METROPOLITAN GOVERNMENT OF NASHVILLE AND DAVIDSON COUNTY

STAFF RECOMMENDATION
1905 Fatherland Street
February 18, 2015

Application: New construction-addition
District: Lockeland Springs-East End Neighborhood Conservation Zoning Overlay
Council District: 06
Map and Parcel Number: 08314017100
Applicant: John Teselle, architect
Project Lead: Paul Hoffman, paul.hoffman@nashville.gov

<p>Description of Project: Construction of a rear addition to this contributing home.</p> <p>Recommendation Summary: Staff recommends approval with the conditions:</p> <ol style="list-style-type: none"> 1. Staff approve the final details, dimensions and materials of windows and doors prior to purchase and installation; and, 2. Staff approve the roof color and masonry color, dimensions and texture; 3. If HVAC and utilities are to be moved, that they be on the rear façade, or on a side façade beyond the midpoint of the house. <p>Meeting these conditions, Staff finds the project meets the design guidelines for the Lockeland Springs-East End Neighborhood Conservation Zoning Overlay.</p>	<p>Attachments A: Photographs B: Site Plan C: Elevations</p>
--	--

| PERSPECTIVE VIEW

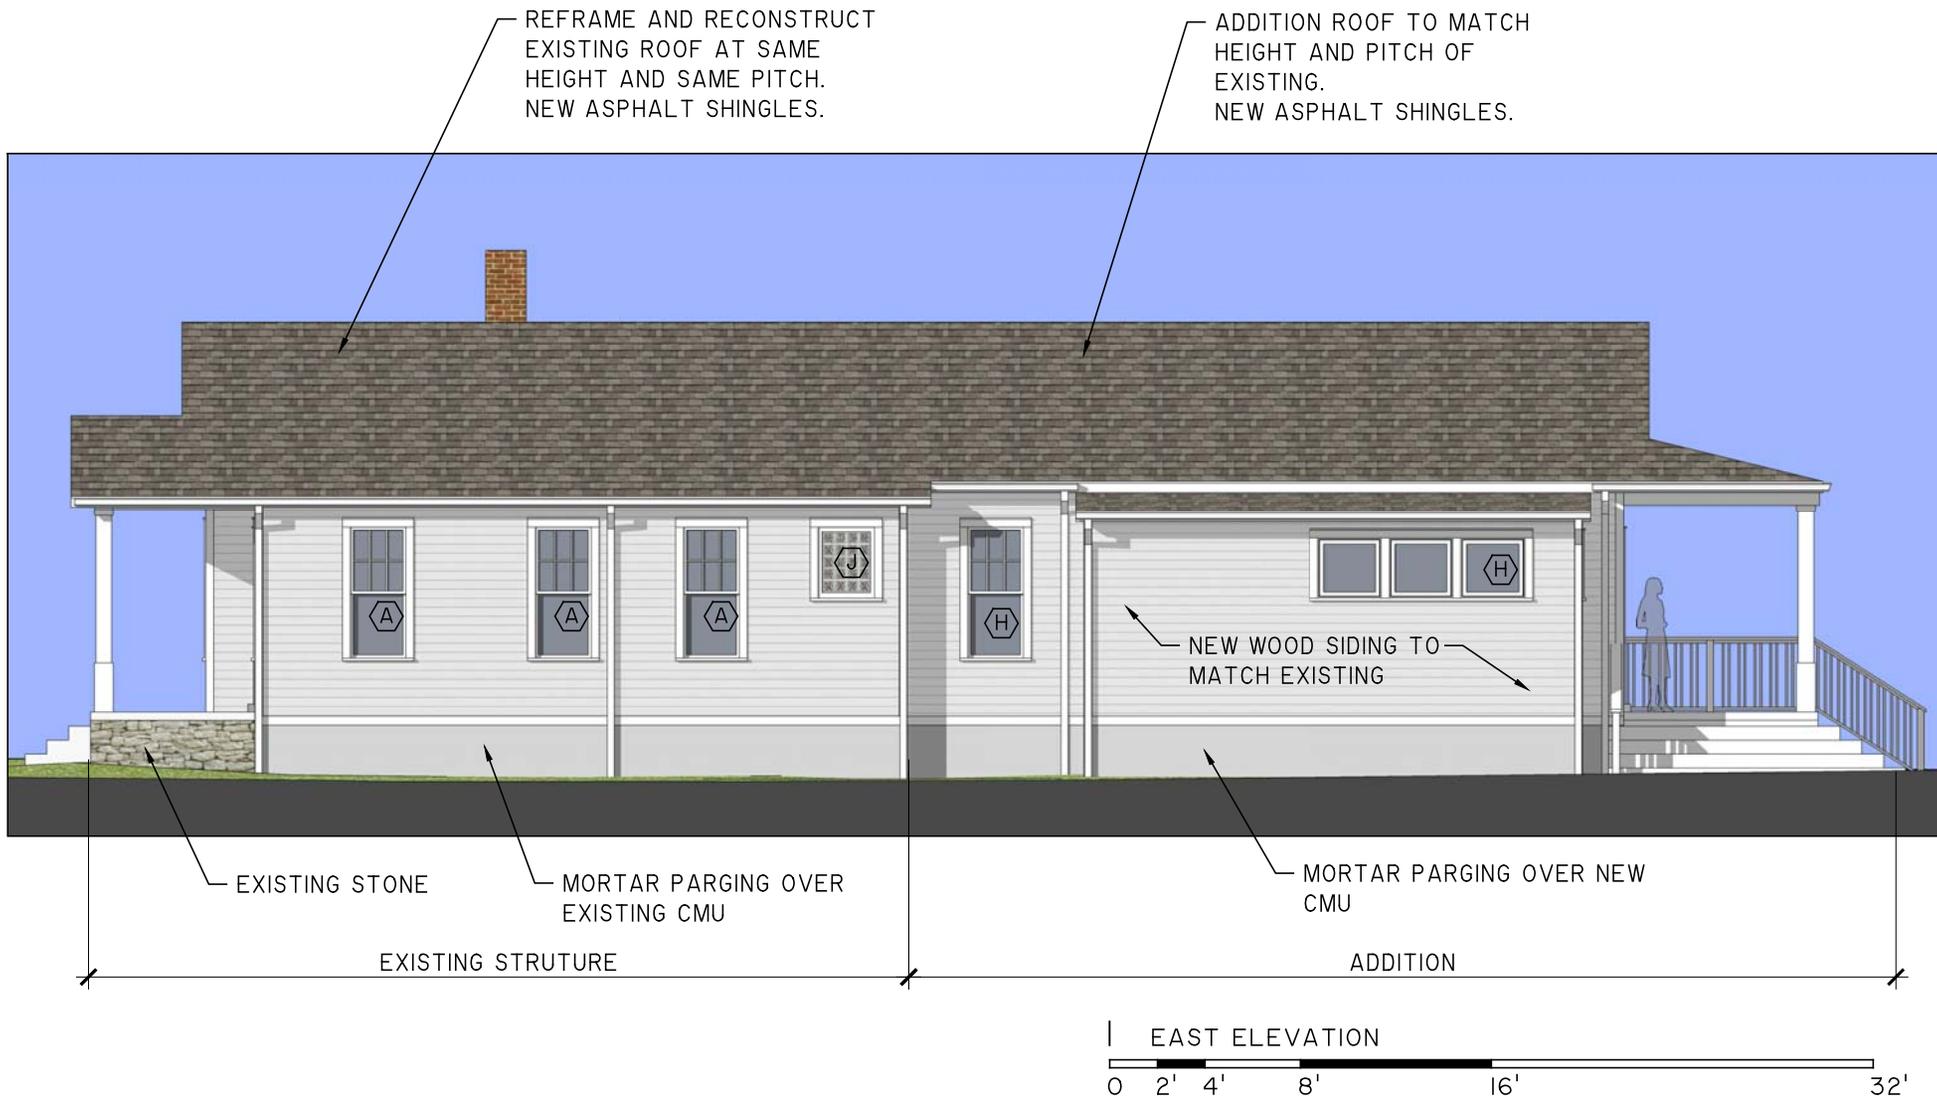
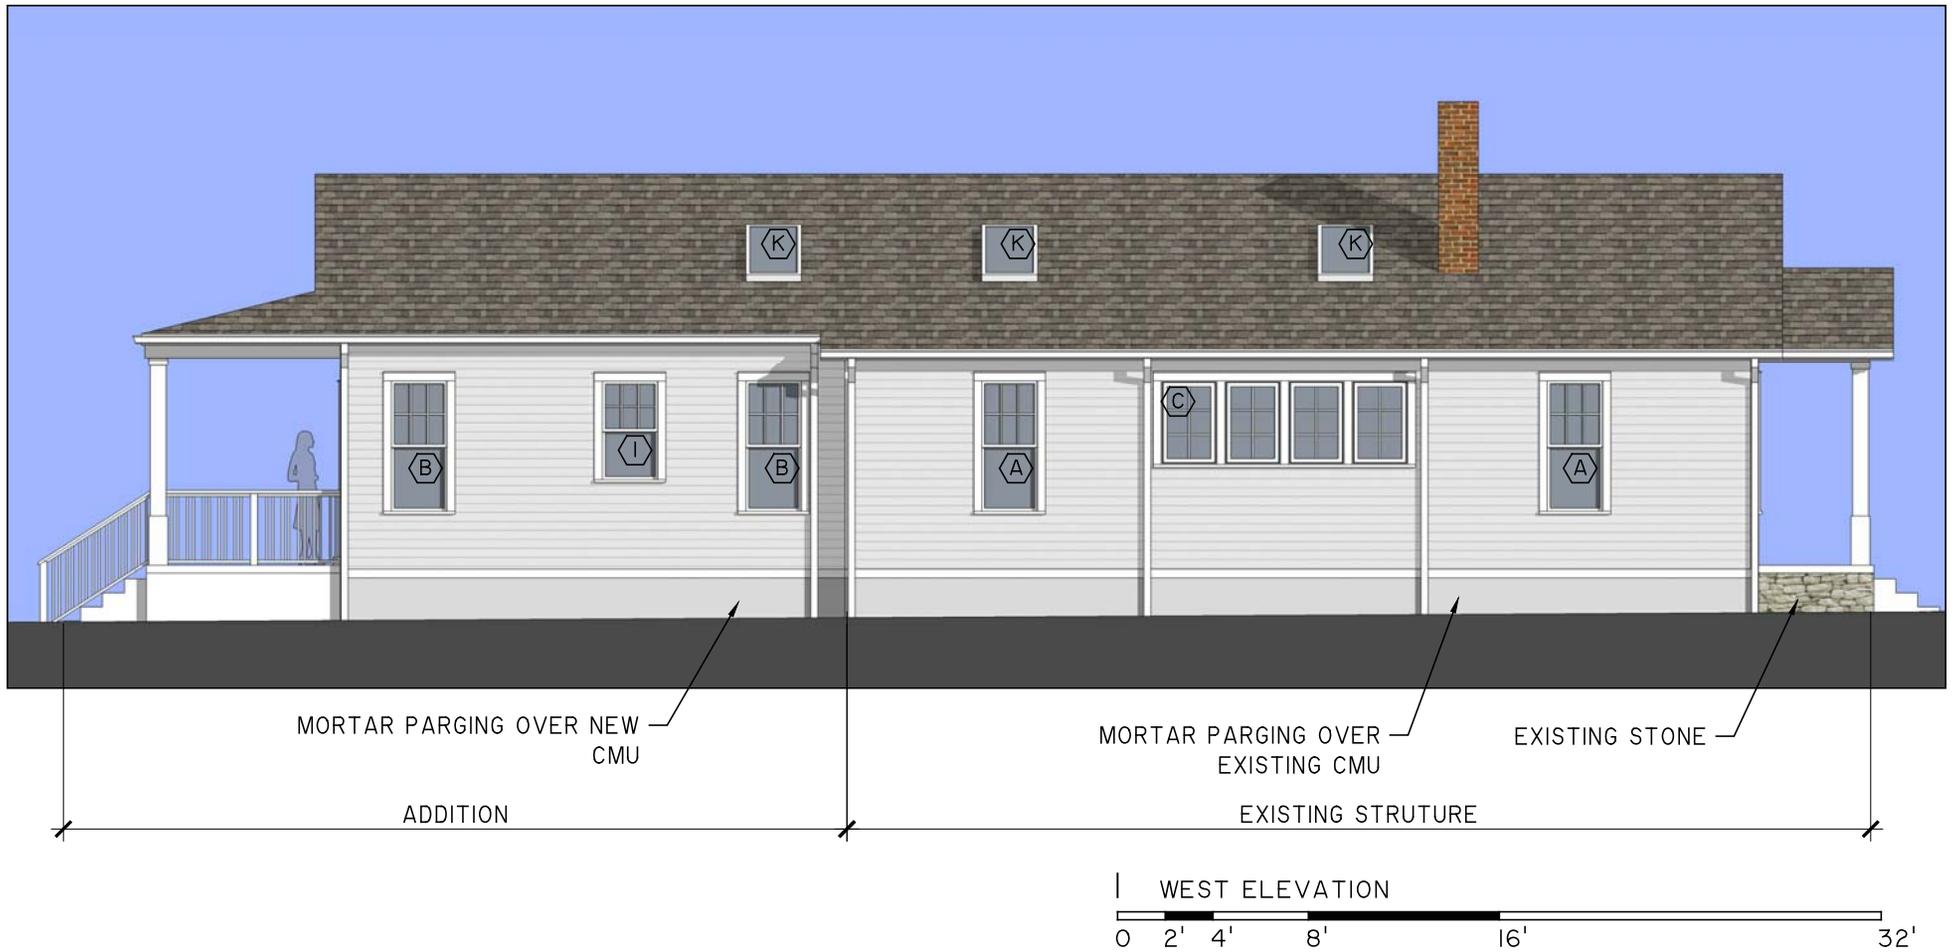
FALSE LOUVER IN EXISTING
WINDOW OPENING (SEE LOFT
FLOOR PLAN)

NEW WOOD COLUMNS ON
FRONT PORCH

NEW OR EXISTING FRONT
DOOR
